Title of Change:	u8FL Wettable Flank with Dummy Tie Bar Approach & Removal of Dry Pack Process for Automotive MOSFET Devices
Proposed Changed Material First Ship Date:	27 Oct 2021 or earlier if approved by customer
Current Material Last Order Date:	05 Sep 2021 <i>Orders received after the Current Material Last Order Date expiration are to be considered as orders for new changed material as described in this PCN. Orders for current (unchanged) material after this date will be per mutual agreement and current material inventory availability.</i>
Current Material Last Delivery Date:	26 Oct 2021 <i>The Current Material Last Delivery Date may be subject to change based on build and depletion of the current (unchanged) material inventory</i>
Product Category:	Active components – Discrete components
Contact information:	Contact your local ON Semiconductor Sales Office or Ammar.Anuar@onsemi.com
PCN Samples Contact:	Contact your local ON Semiconductor Sales Office to place sample order or <PCN.samples@onsemi.com> . Sample requests are to be submitted no later than 45 days after publication of this change notification. Samples delivery timing will be subject to request date, sample quantity

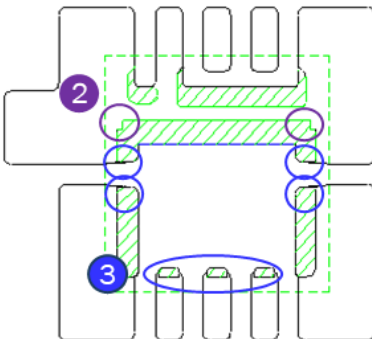
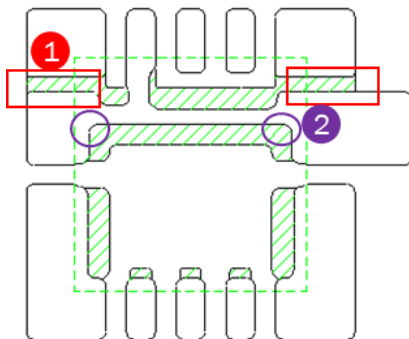
This Product Change Notification is intended to inform the customer that the Wettable Flank leadframe design and plating process are being enhanced, as tabulated below, in order to improve the sidewall plating and the elimination of Dry Pack.

Before Change	After Change
Wettable Flank Plating Site	Metek, Malaysia (Sub-con)	ON Seremban, Malaysia
u8FL HEFET Lead Frame design	1. No tie bar connect to the gate and source lead 2. Corner of the coining area-irregular. 3. 0-30um gap between coining area to tie bar/lead 	1. Additional tie bar connect to gate and source lead 2. Corner of the coining area-smooth radius 3. No gap between coining area to tie bar/lead- soft coining method 
u8FL HEFET Case Outline	511DY	515AP
Sidewall Plating Method	Electroless SN plating	Electrolytic SN plating
Packing	Drypack (MSL 1)	No Drypack (MSL 1)

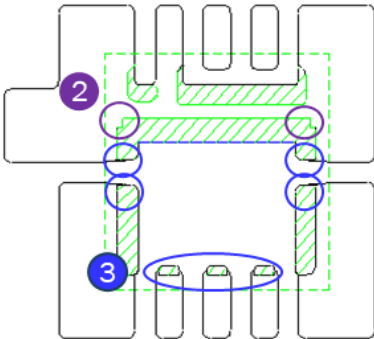
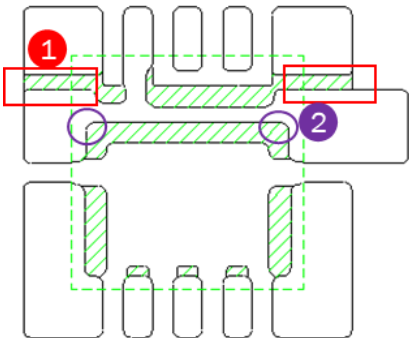
本製品変更通知は、以下の表に示すように、側面のめっきを改良し、ドライパックを廃止するために、ウェットブルフランクのリードフレーム設計およびめっきプロセスを向上することをお客様にお知らせするものです。

変更前の表記	変更後の表記
ウェットブルフランクめっき拠点	メテック、マレーシア (サブコン)	オンセレンバン、マレーシア
u8FL HEFET のリードフレーム設計	1. ゲートとソースリードに接続されるタイバーはありません 2. コイニングエリアのコーナーが変則的 3. コイニングエリアとタイバー/リードの間に 0-30um の間隔 	1. 追加のタイバーがゲートとソースリードに接続されています 2. コイニングエリアのコーナーの半径がなめらか 3. ソフトコイニング方法により、コイニングエリアとタイバー/リードの間に間隔なし 
u8FL HEFET ケースアウトライン	511DY	515AP
側面のめっき方法	Electroless SN plating	Electrolytic SN plating
梱包	Drypack (MSL 1)	No Drypack (MSL 1)
